WELL NO. Federal 12-4

APPLICATION FOR PERMIT TO DRILL, DEEPEN, OR PLUG BACK

: DISTRICT ENGINEER, O&G, S/ LAKE CITY, UTAH
ECT: APD MINERAL EVALUATION REPORT LEASE NO. V-15049
ATOR: Four "D" Oil Company WELL NO. Fed 12-4
TION: 1/4 NW 1/4 NW 1/4 sec. 12, T. 20S, R. 23E, SLM.
Grand County, Utah

On October 23, 1979, Four "D" Oil Company filed an Application for Permit to Drill the No. 12-4 development well, a 2500' oil test of the Salt Wash Formation and the Entrada Sandstone; located at an elevation of 4728' in the NW/4, NW/4, Sec. 12, T20S, R23E on Federal mineral lands and public surface; lease No. U-15049.

WESTERN ENGINEERS, INC.	
SITE LAYOUT	
4-D OIL COMPANY	
FEDERAL 12-4	
GRAND COUNTY, UTAH	
Surveyed D.L.B.	Drawn R.W.Q.
Grand Junction, Colo.	9/28/79

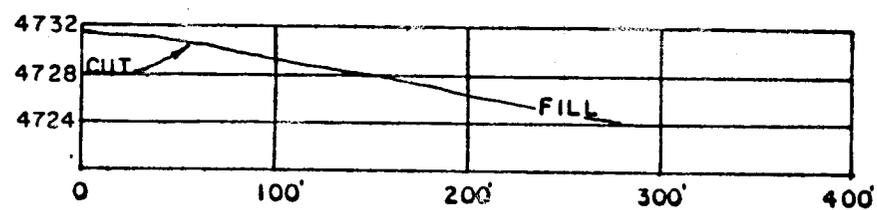
The mud and reserves pits would contain all fluids used during the drilling operations. To allow for the stockpiling of topsoil on the SE corner of the pad, the reserve pit should be moved 30' to the north. The operator agreed to this at the onsite inspection. A covered trash pit would be utilized for any solid wastes generated at the site and would be buried at the completion of the operations. Sewage would be handled according to State sanitary codes. For further information, see the 13-Point Surface Plan.

MAP "A"

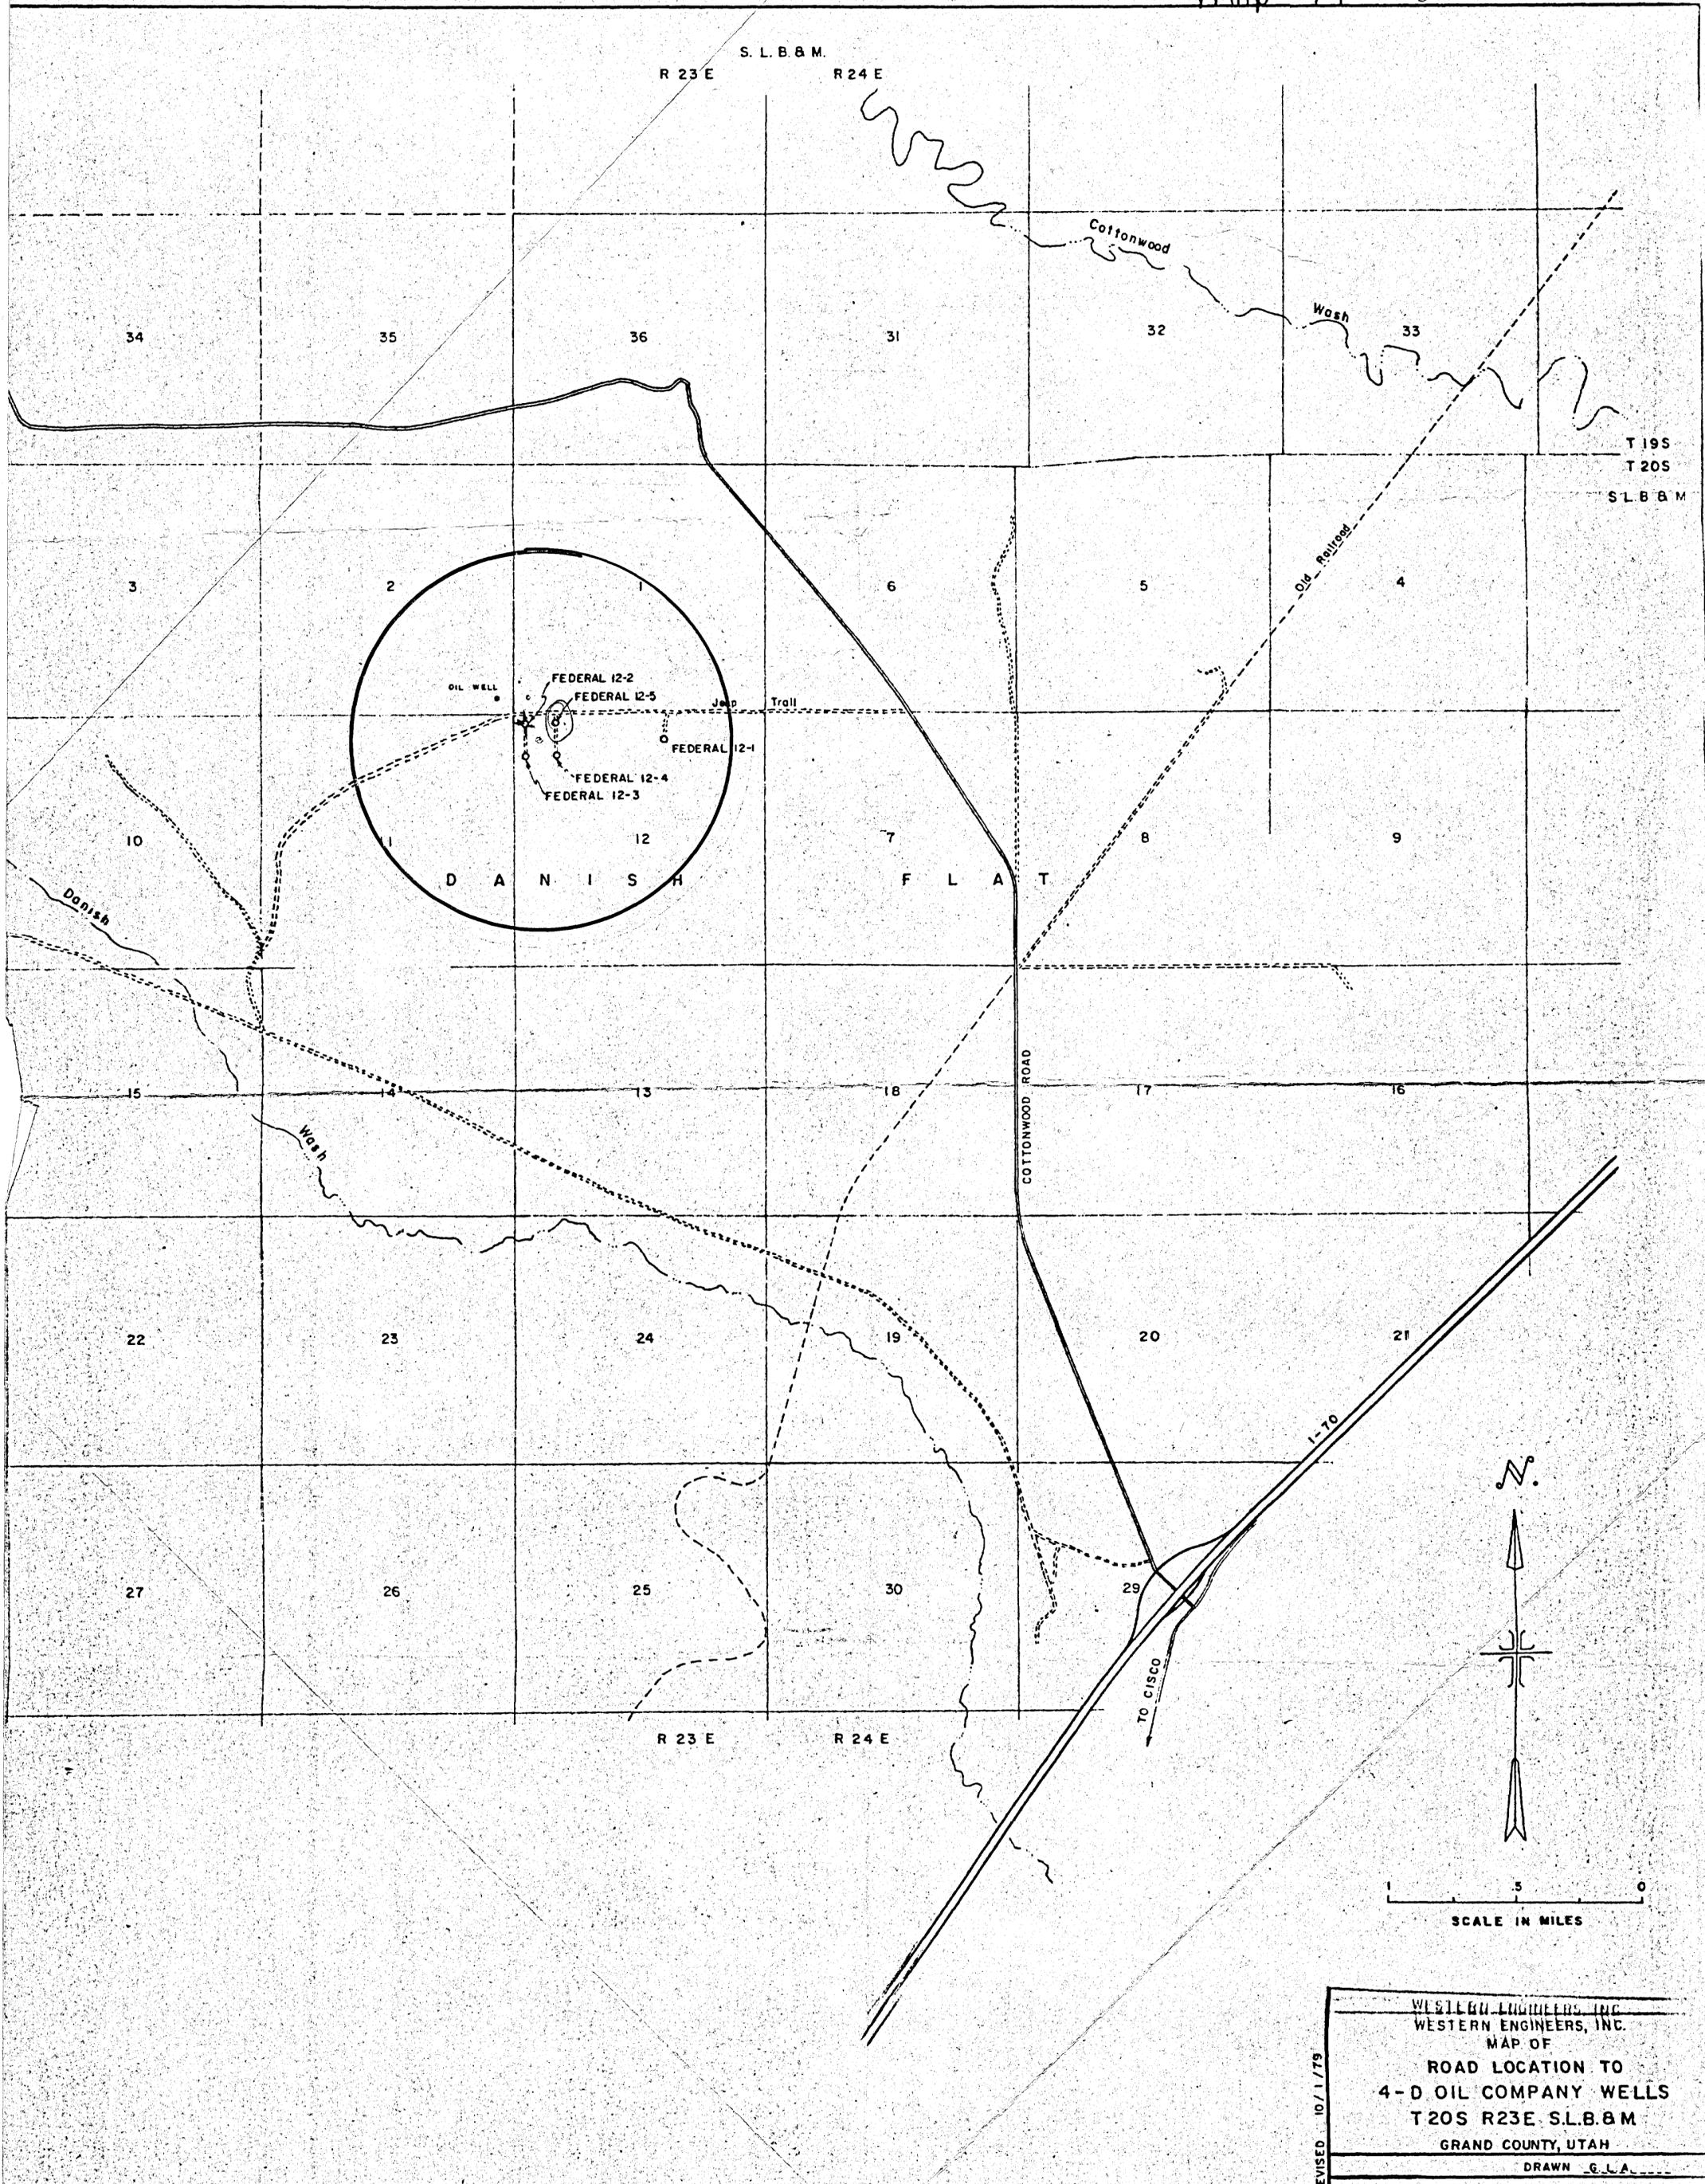
There was no objection raised to the wellsite. As an objection was raised to the access road, it was changed. See attached map for new access road.

- 1) Operator will construct a new access road 16' wide x approximately 300' long, originating from the west edge of the already constructed #12-5 wellsite.
- 2) Operator will fence reserve pit on three sides prior to drilling and during drilling activities, and on four sides once the rig has moved off.
- 3) 8" of topsoil will be stockpiled on the SE corner of the wellsite, away from the reserve pit.
- 4) The reserve pit would be moved 30' to the north to allow for stockpiling of topsoil on the SE corner of the pad.
- 5) Operator will maintain the blooie line at least 125' from the wellhead and direct it into an approved pit.
